Docket No. 50-336
B18294

Millstone Nuclear Power Station, Unit No. 2
Response to a Request For Additional Information Regarding Proposed Revision to
Final Safety Analysis Report
Fuel Centerline Melt Linear Heat Rate Limit (PLAR 2-00-2)

**Response to a Request For Additional Information Regarding Proposed Revision
to Final Safety Analysis Report
Fuel Centerline Melt Linear Heat Rate Limit (PLAR 2-00-2)**

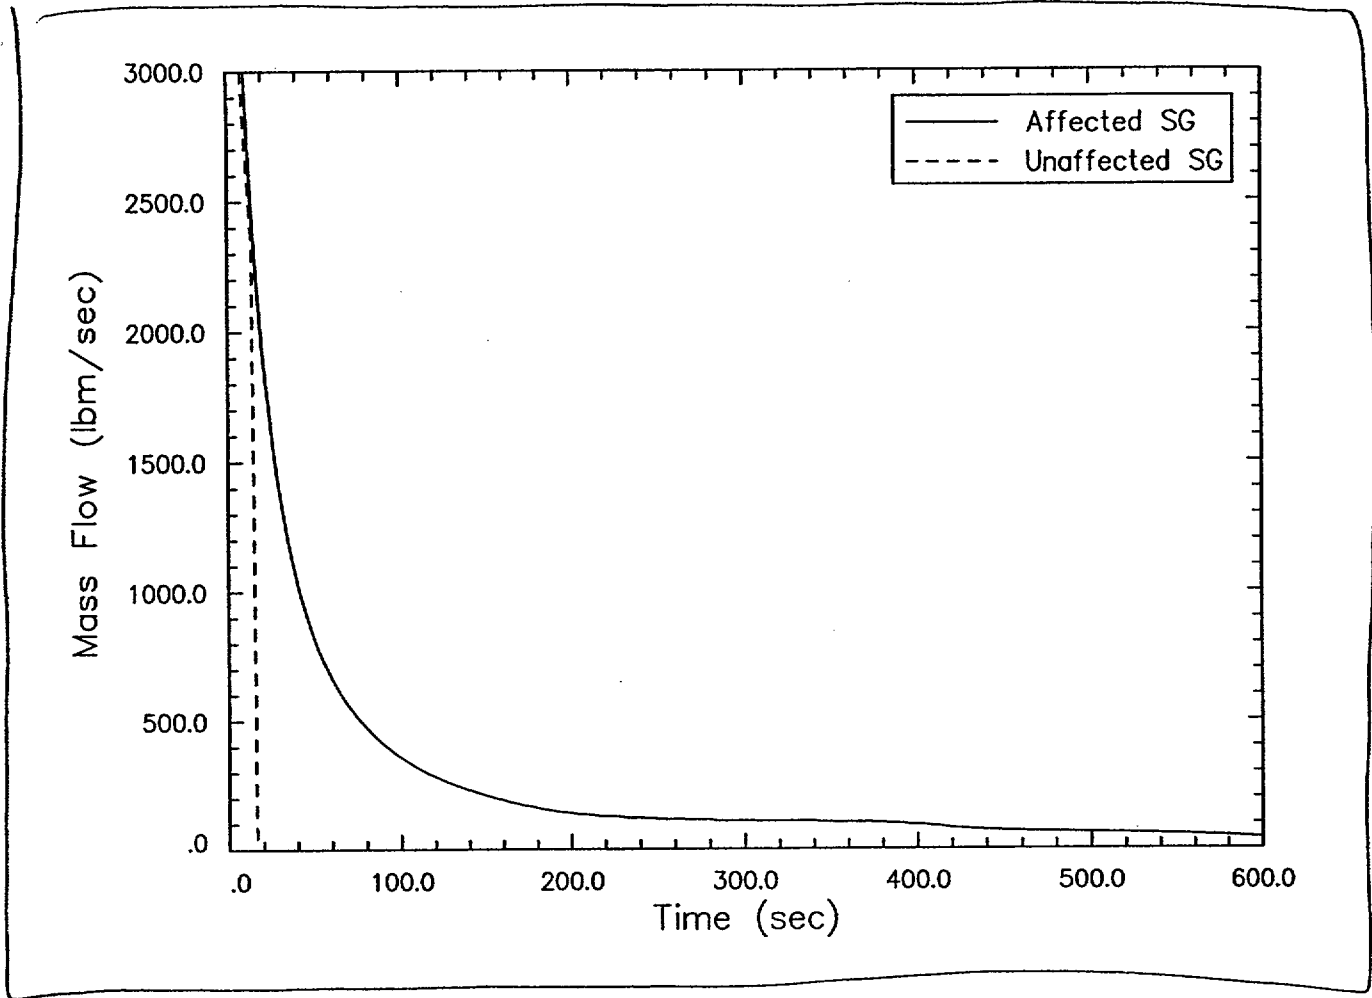
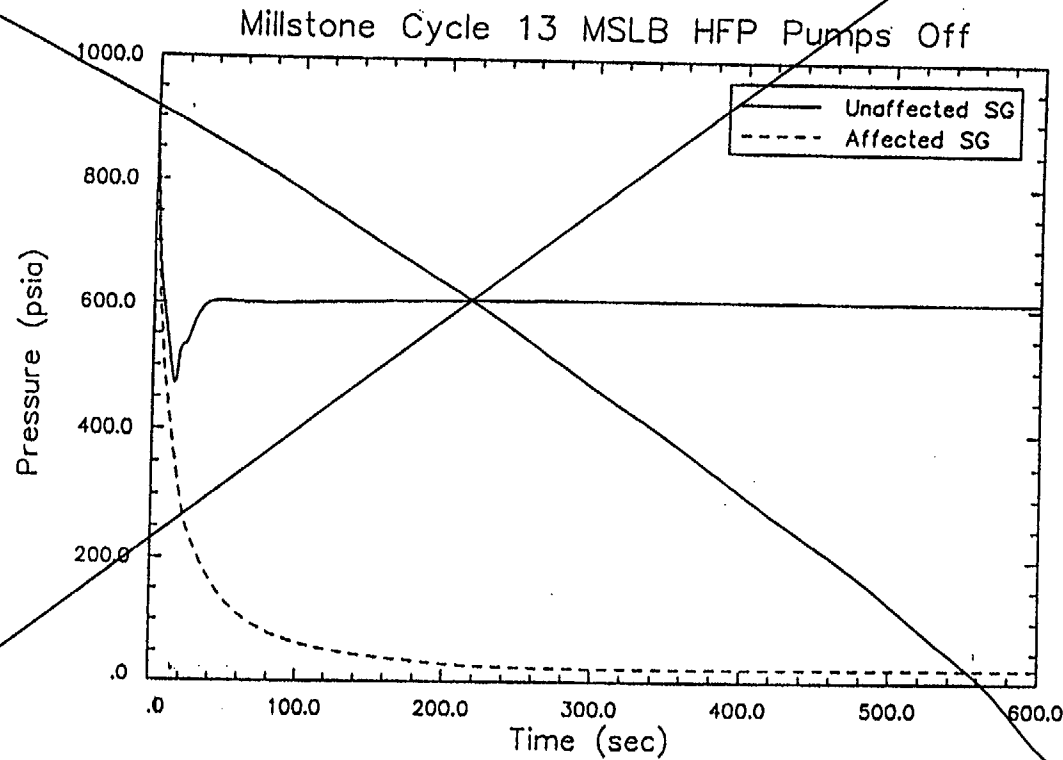
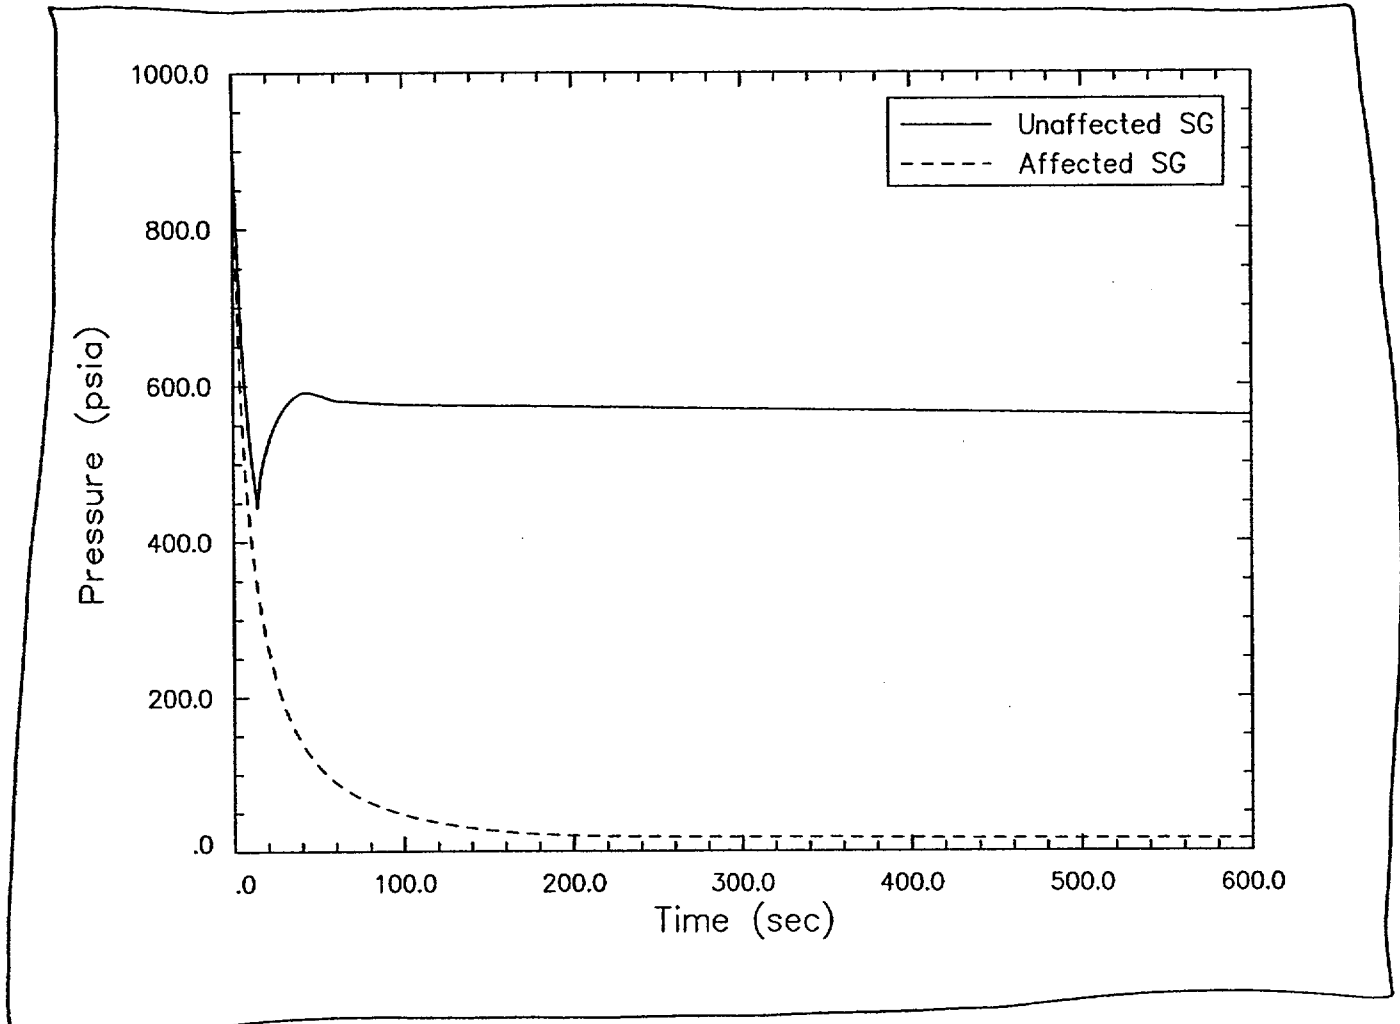
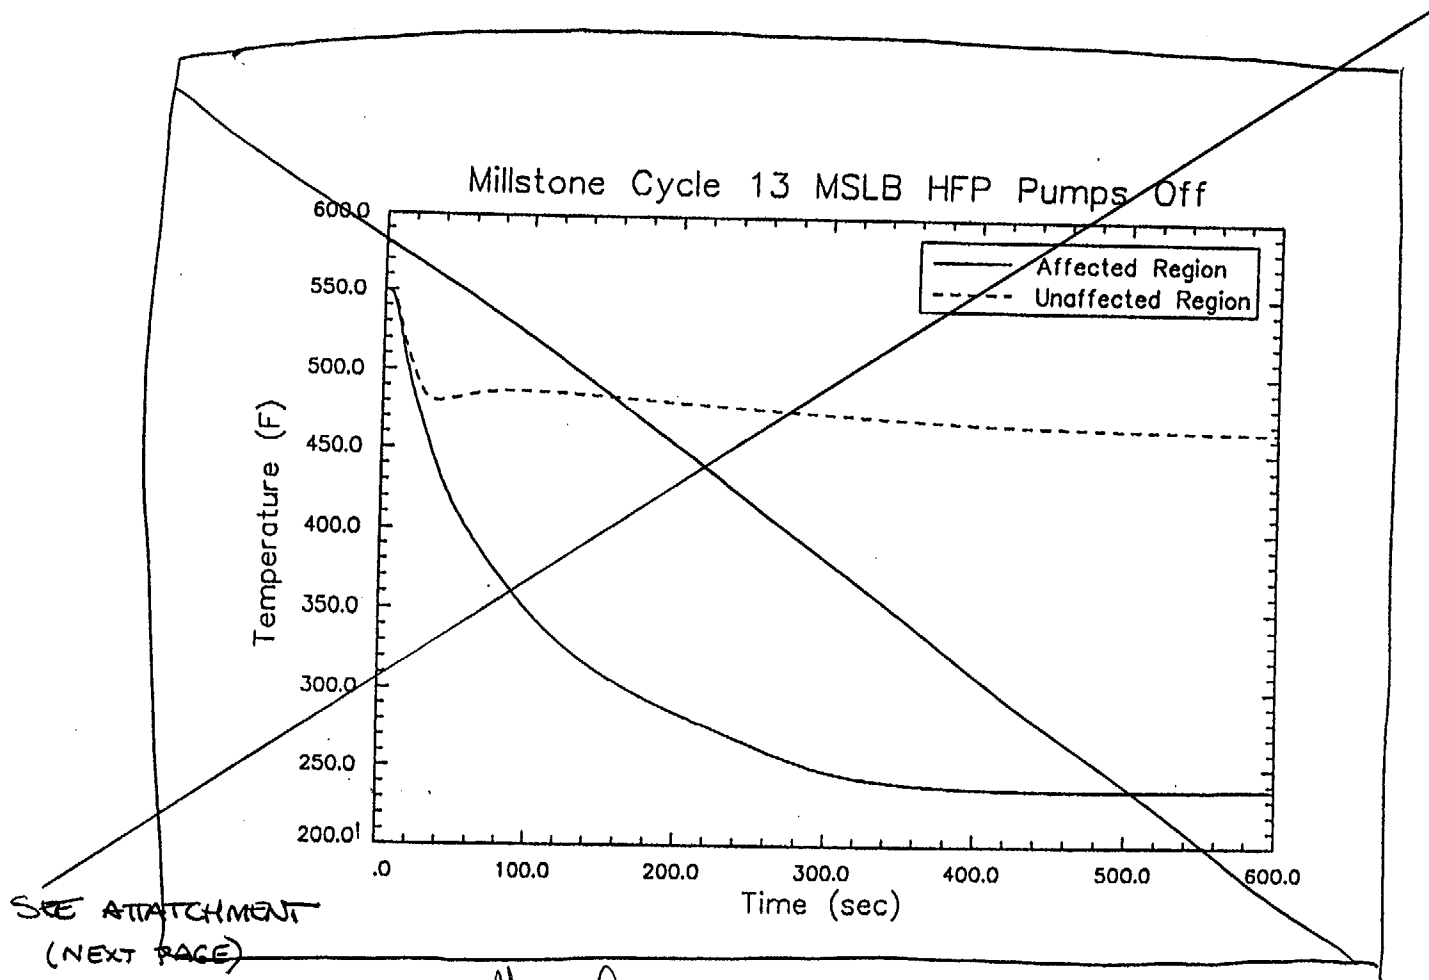
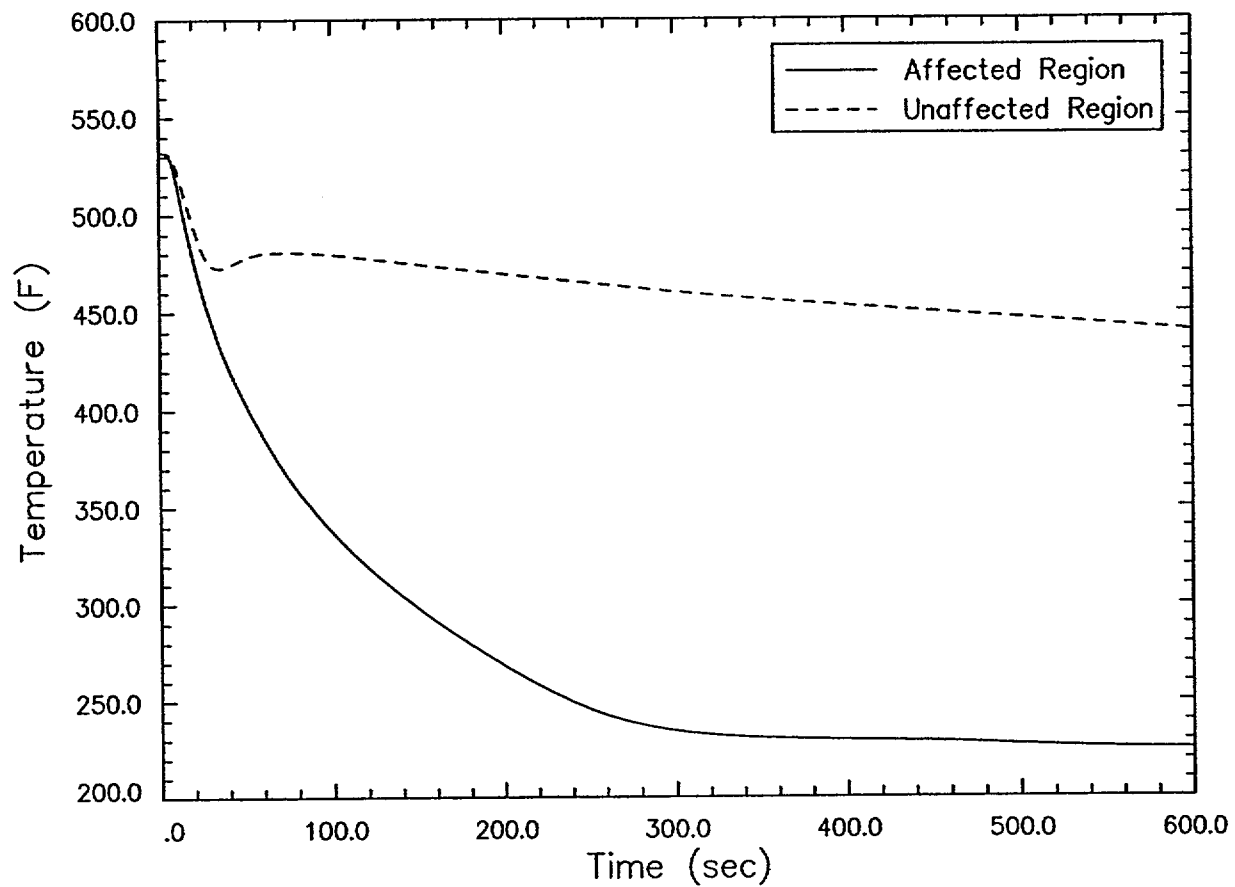
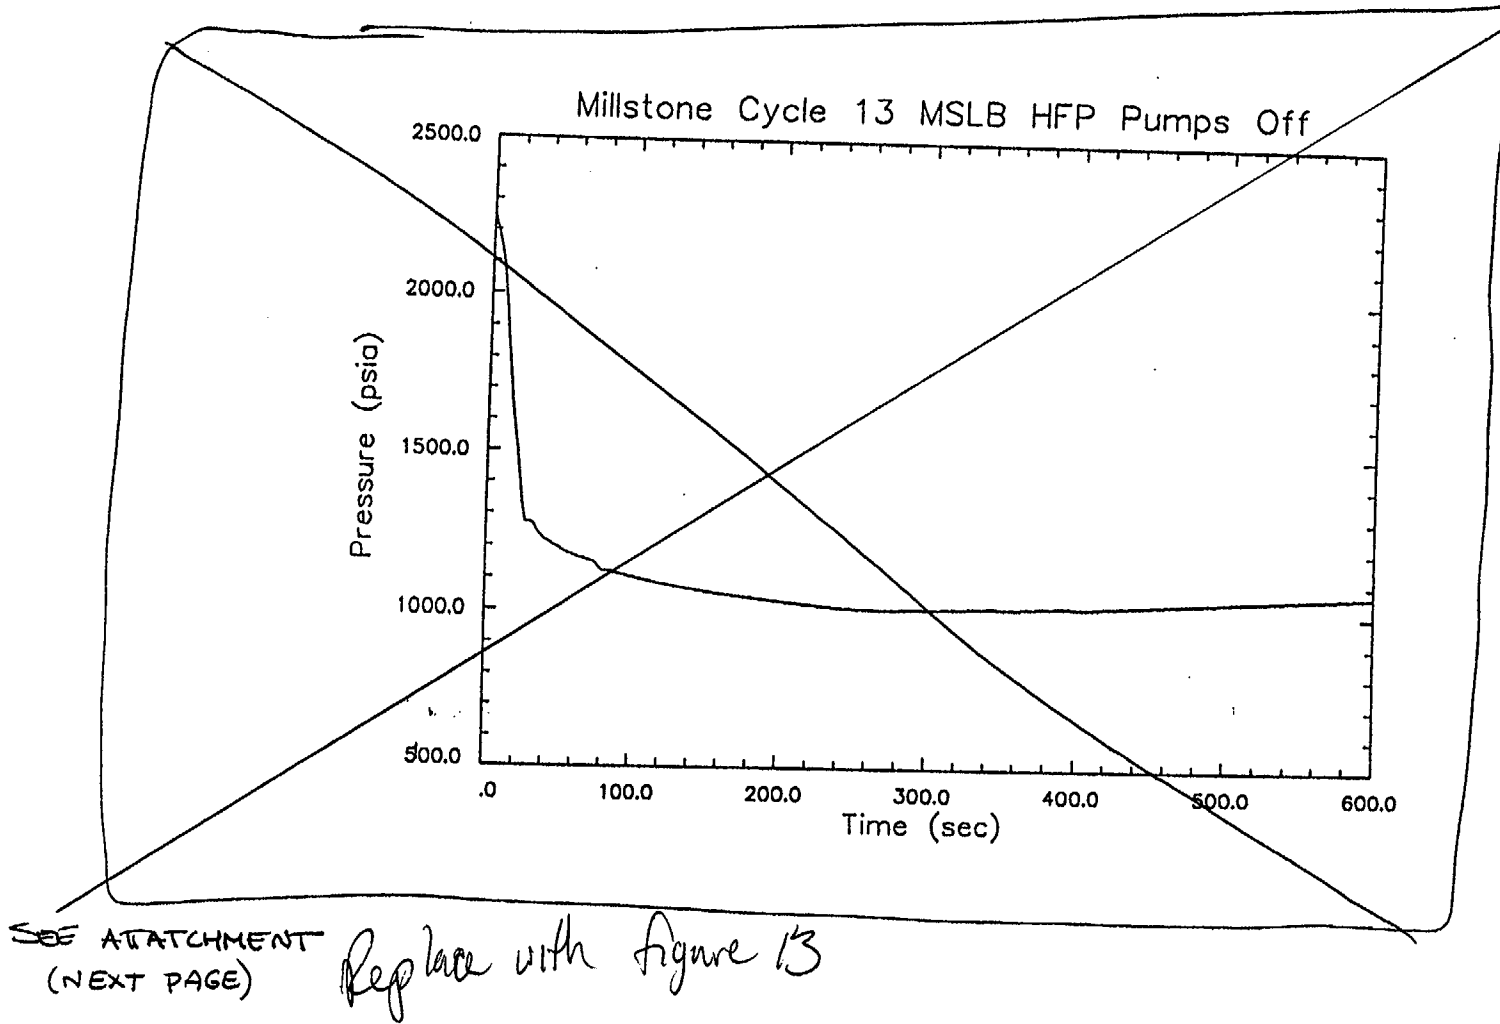
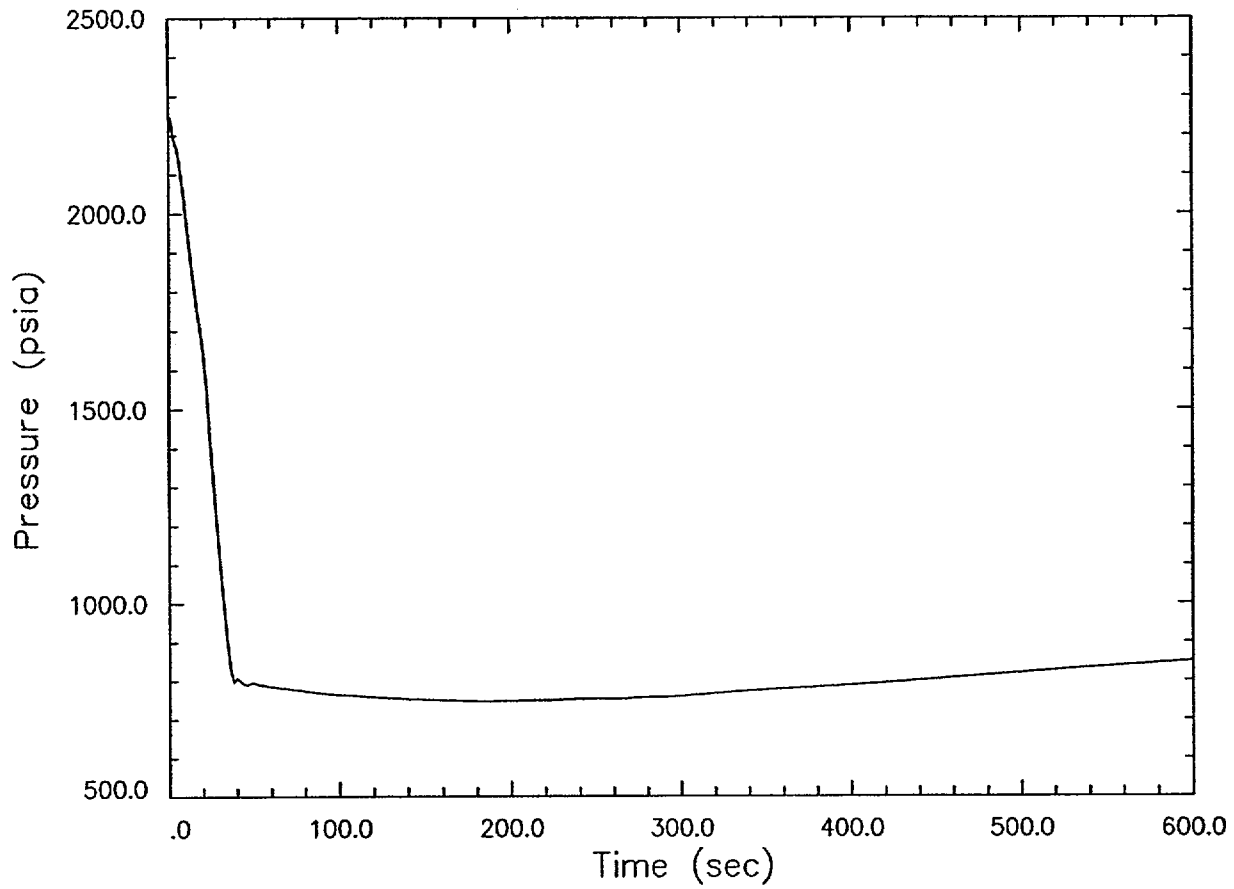
Section 14.1.5.2.6.2 refers to Figs. 14.1.5.2-10 through 14.1.5.2-16 and Table 14.1.5.2-8 as representative of the HZP SLB event outside containment. However, these figures and table previously referred to the HFP event. Should they be revised accordingly?

The cited figures and table have been updated by an earlier FSAR change associated with the Cycle 14 reload design change. To provide more clarification, Attachment 2 includes a markup of the FSAR Section 14.1.5, including the associated tables and figures. This attachment includes the changes to FSAR Section 14.1.5 associated with the Cycle 14 SLB reanalyses, and the proposed changes associated with the change to a cycle specific linear heat rate limit. The changes associated with the Cycle 14 SLB reanalyses are identified by FSAR Change Numbers 00-MP2-23 and 00-MP2-39 in the attachment. The proposed changes associated with the cycle specific linear heat rate limit are identified by FSAR Change Number 00-MP2-38 in the attachment.
